METROPOLITAN GOVERNMENT OF NASHVILLE AND DAVIDSON COUNTY

STAFF RECOMMENDATION
1608 16th Avenue South
April 19, 2017

Application: New construction – addition; Setback determination
District: South Music Row Neighborhood Conservation Zoning Overlay
Council District: 19
Map and Parcel Number: 10408035000
Applicant: Chris Gill
Project Lead: Sean Alexander, sean.alexander@nashville.gov

1 SITE PLAN
1/16" = 1'-0"

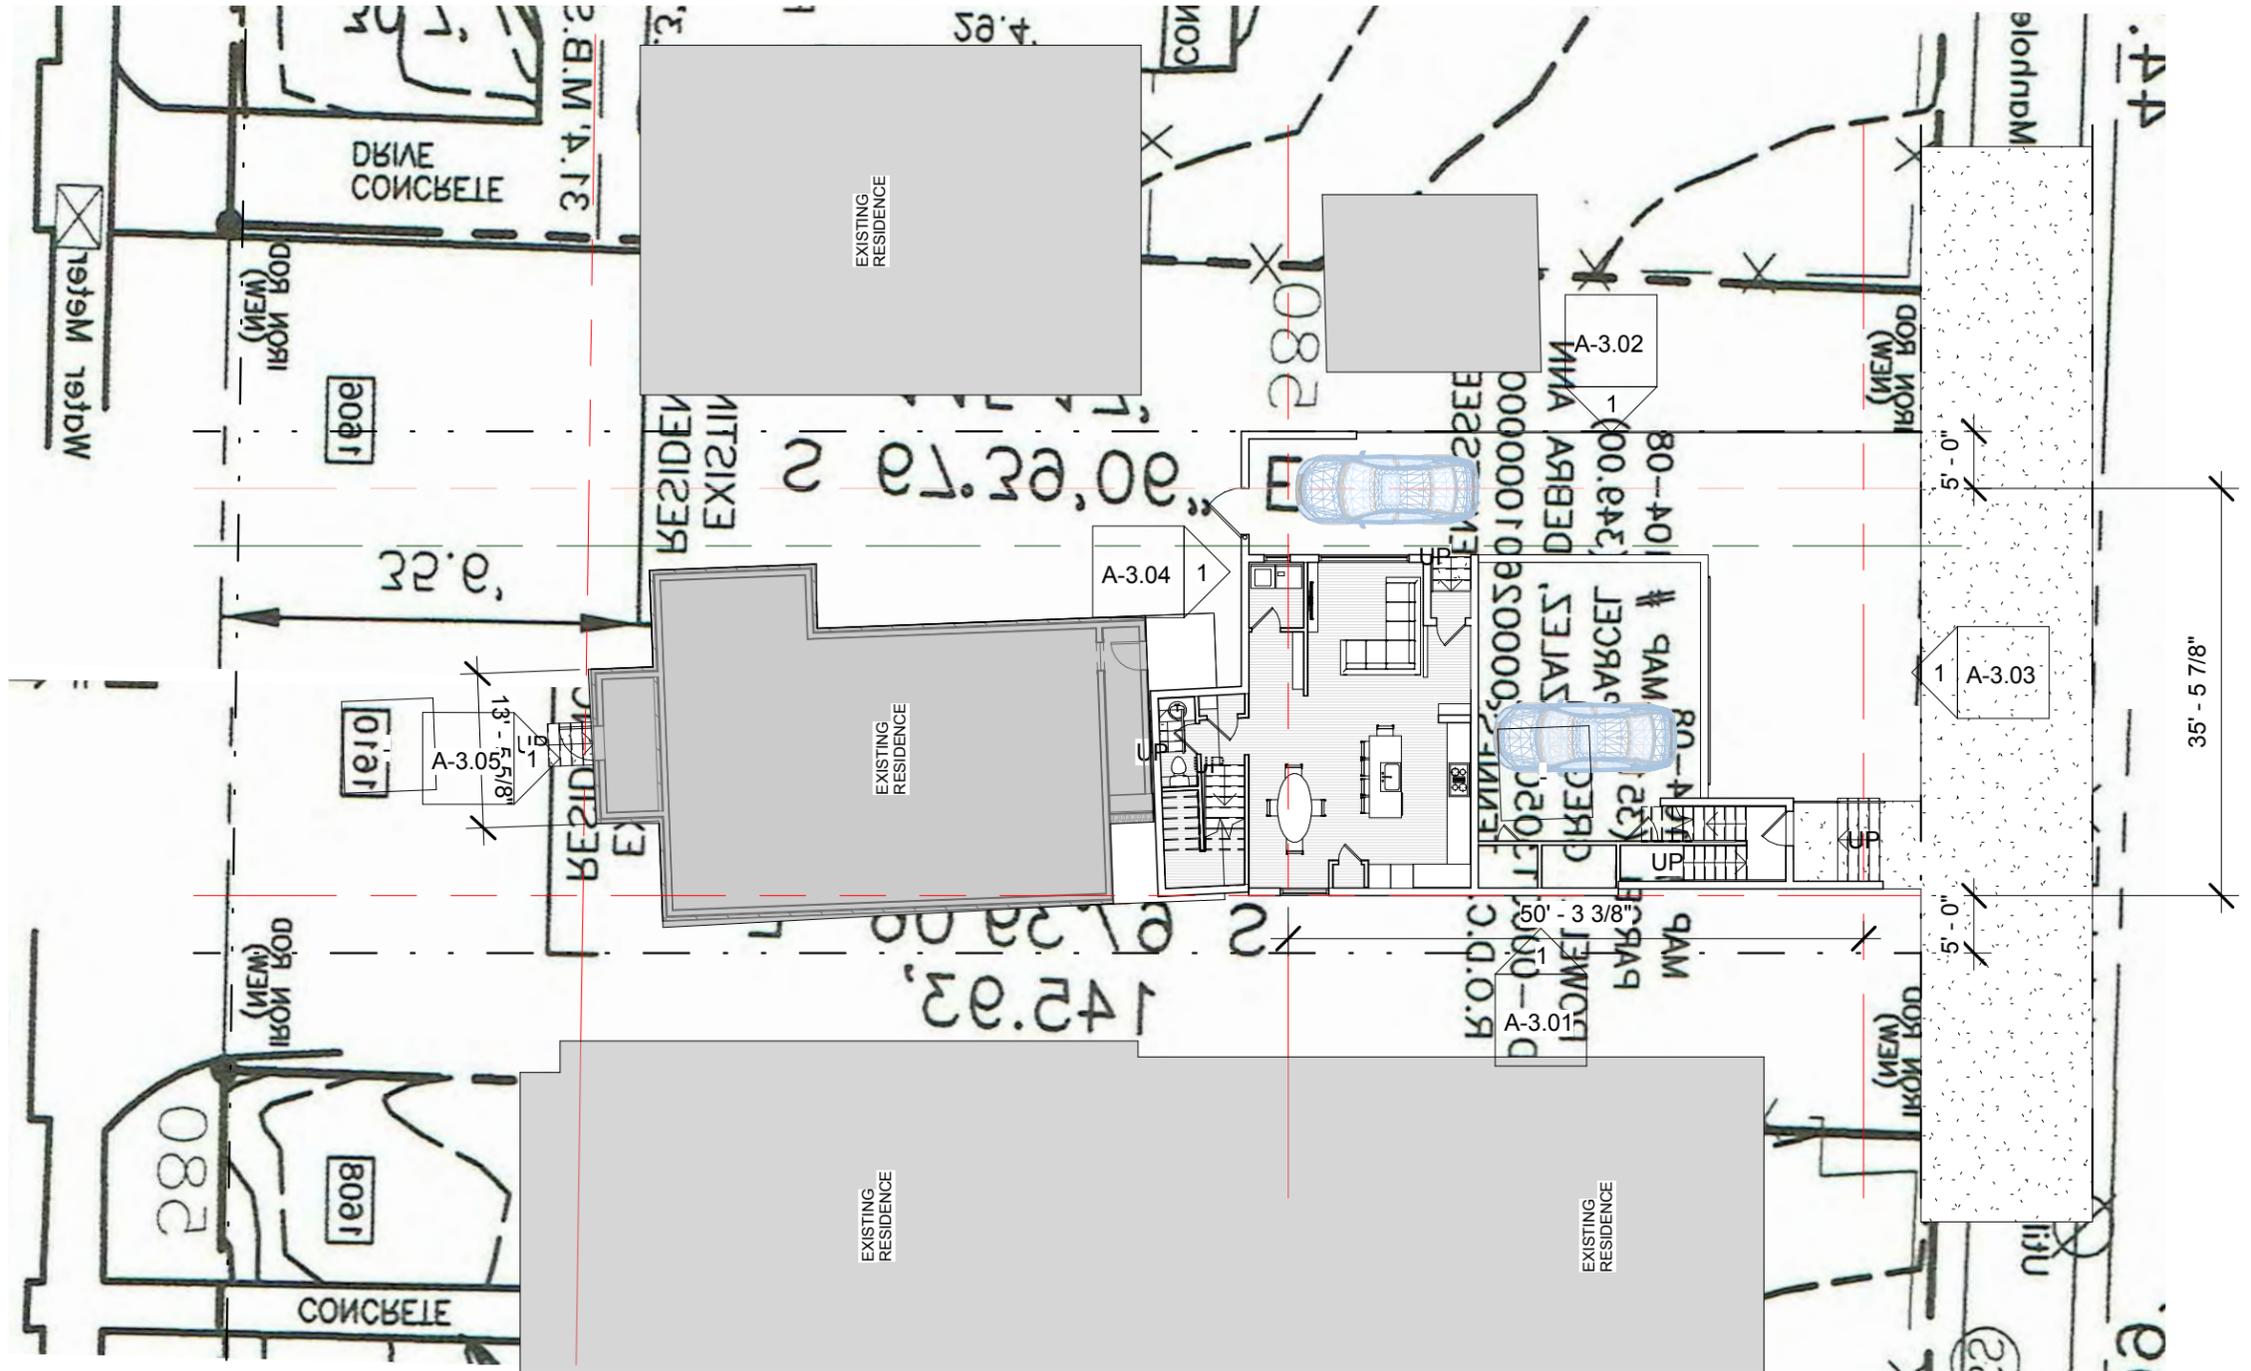
Setback & Rhythm of Spacing: The addition starts with a hyphen connection behind the historic house, eighty feet (80') back from the street and extending fifty feet (50') to the rear. This gives the building a rear setback of only fifteen feet (15'). This rear setback is similar to other buildings in the surrounding area, including an addition to the adjacent building to the right, but it requires a setback determination from the bulk zoning requirement of twenty feet (20'). The addition will be behind the historic building, aligned with the right side of the existing building on the right side and stepped out four feet (4') on the left, giving it side setback on the left and right of five feet (5'). The project meets the side setback requirements and Staff finds the project to meet section II.B.1.a of the design guidelines.

Appurtenances & Utilities: A new driveway will be added at the rear of the lot, accessed from the alley. A stone-veneered privacy wall will screen the driveway from the front. No other changes to the site's appurtenances were indicated on the drawings. The location of the HVAC and other utilities was also not noted. Staff asks that the

HVAC be located on the rear façade, or on a side façade beyond the midpoint of the house. The project meets section II.B.1.i of the design guidelines.
